**Appointed examiner's audit of Exceptional Event Claim -
Northern Powergrid (Northeast)
33kV Incident at Scarborough Grid Substation
11 April 2013**

Title: Northern Powergrid – Audit of Exceptional Event Claim – Northern Powergrid (Northeast) – Scarborough Grid Substation – 11 April 2013

Reference: ep/Ofgem/NPG/11 Apr '13

Date: 18 October 2014

Figure 1 – Simplified Network Diagram of NPG's 132/66/33kV distribution networks affected by the incident

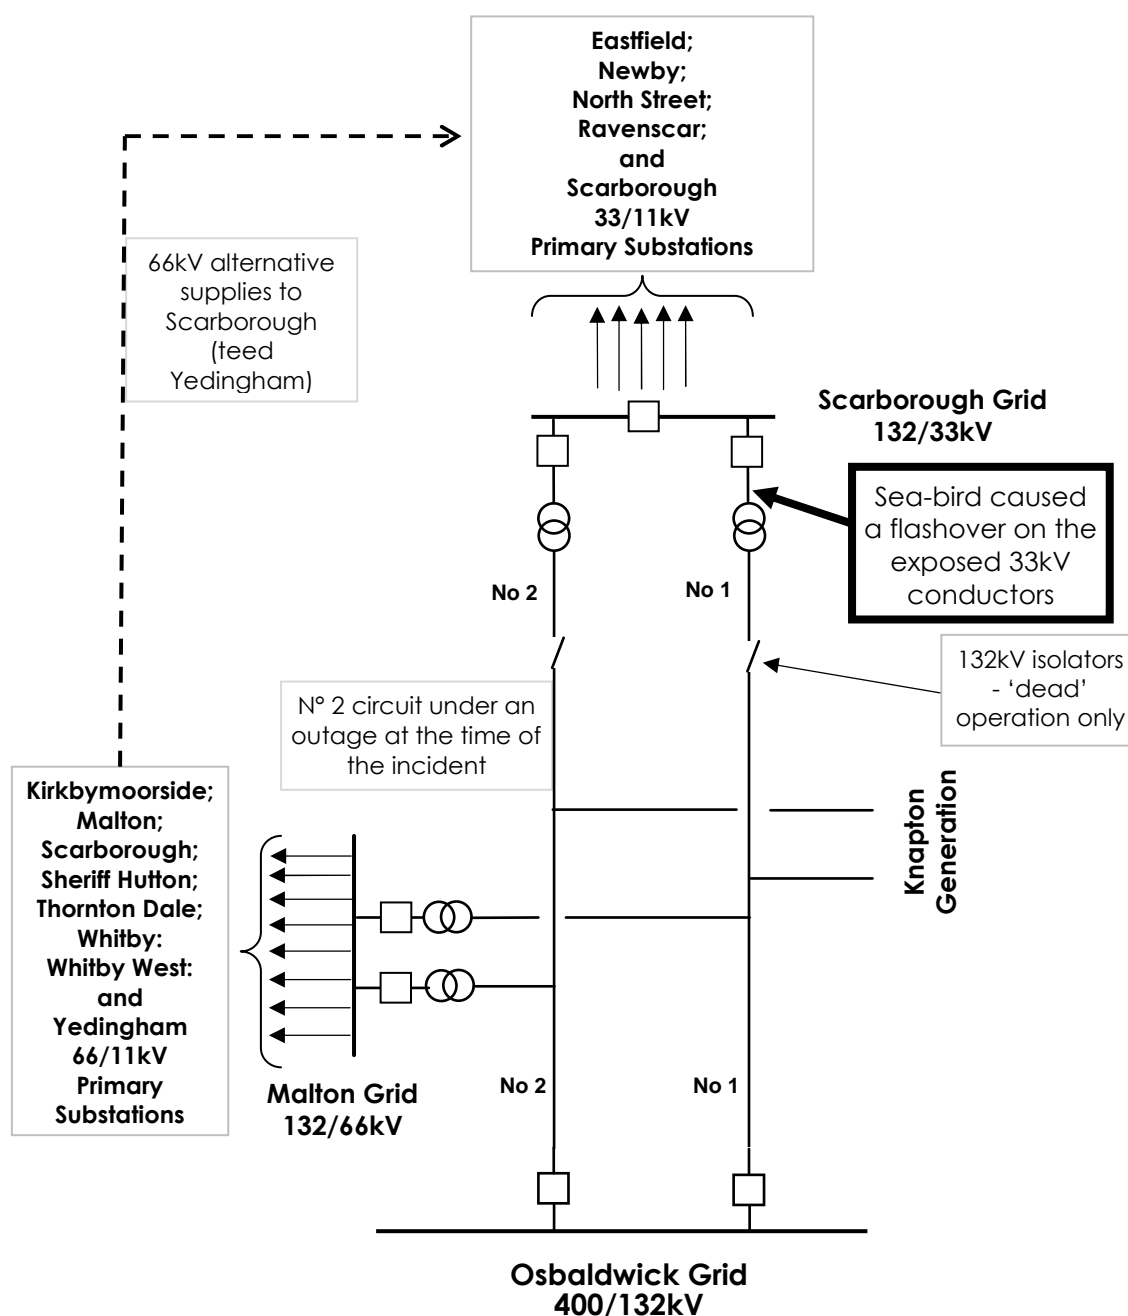
34. Apart from the above on-going outage, NPG's network was restored to normal running.
35. A simplified view of the sections of NPG's 132/66/33kV networks affected by this event is shown in Figure 1.
